DUANE ARNOLD ENERGY CENTER

AMENDMENT TO FACILITY OPERATING LICENSE

Amendment No. 98
License No. DPR-49

ATTACHMENT TO LICENSE AMENDMENT NO. 98

FIGURE 3.12-5

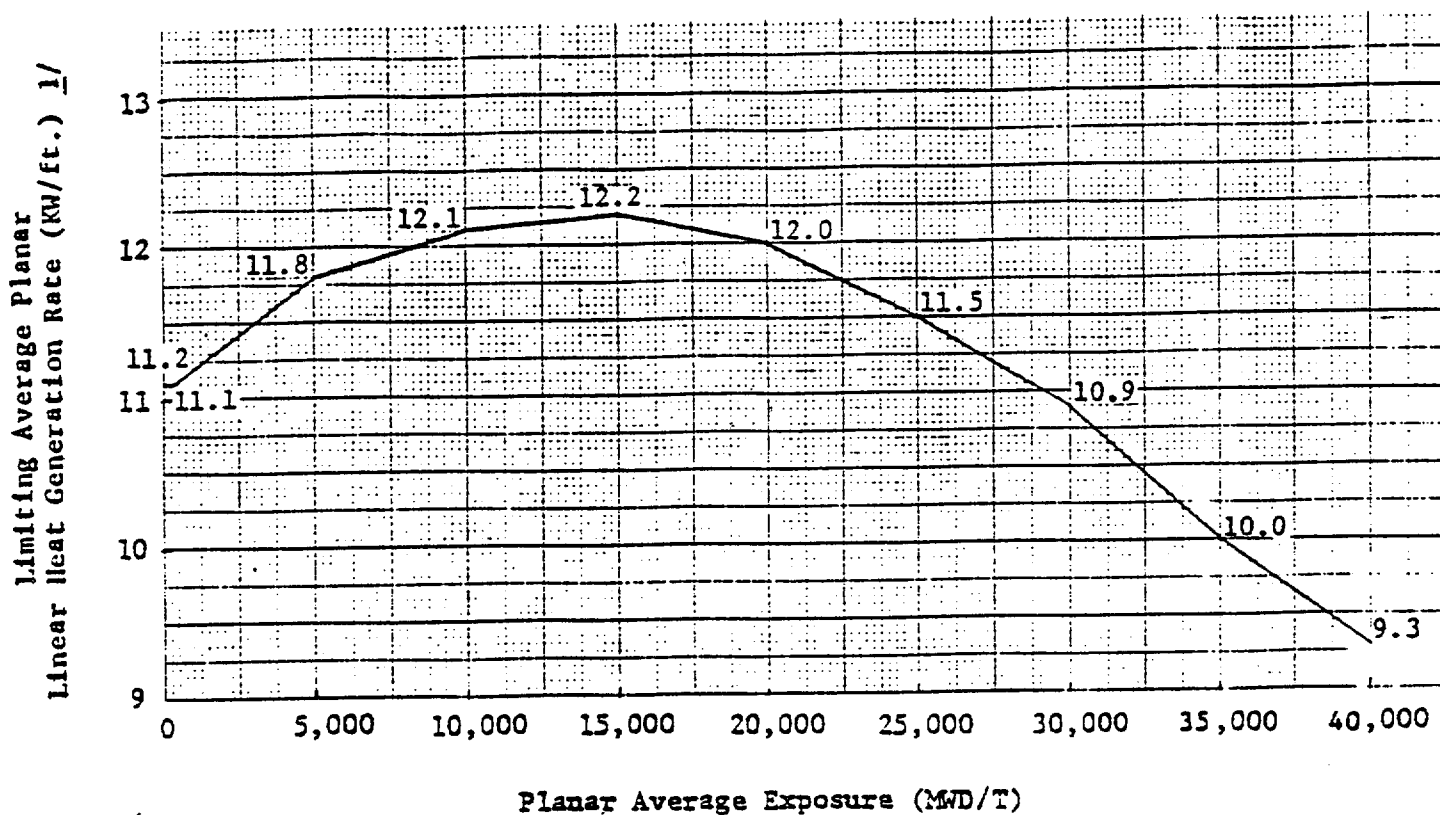
1/ When core flow is equal to or less than 70% of rated, the MAPLHGR shall not exceed 95% of the limiting values shown.

FUEL TYPE: 8D274L

DUANE ARNOLD ENERGY CENTER
IOWA ELECTRIC LIGHT AND POWER COMPANY
TECHNICAL SPECIFICATIONS
LIMITING AVERAGE PLANAR LINEAR HEAT GENERATION RATE AS A FUNCTION OF PLANAR AVERAGE EXPOSURE
FUEL TYPE: P8DP3289
FIGURE 3.12-7

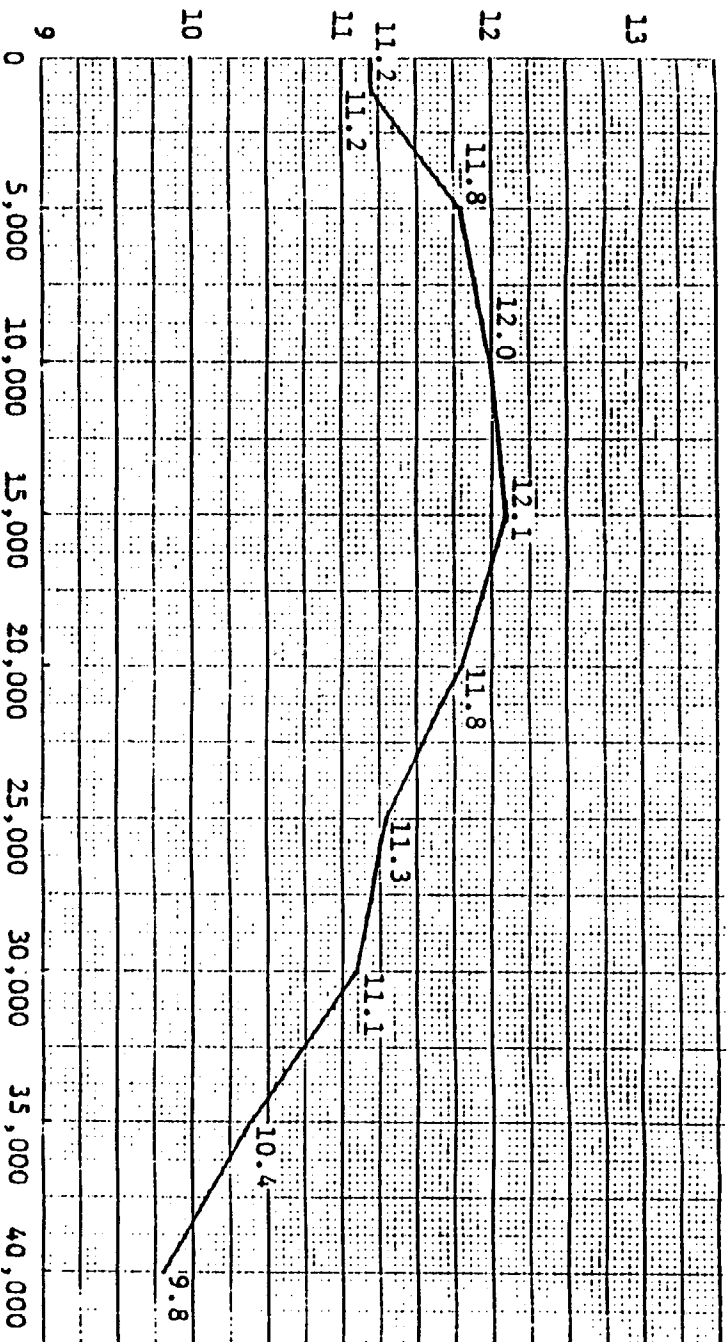
^{1/} When core flow is equal to or less than 70% of rated, the MAPLBCA shall not exceed 95% of the limiting values shown.
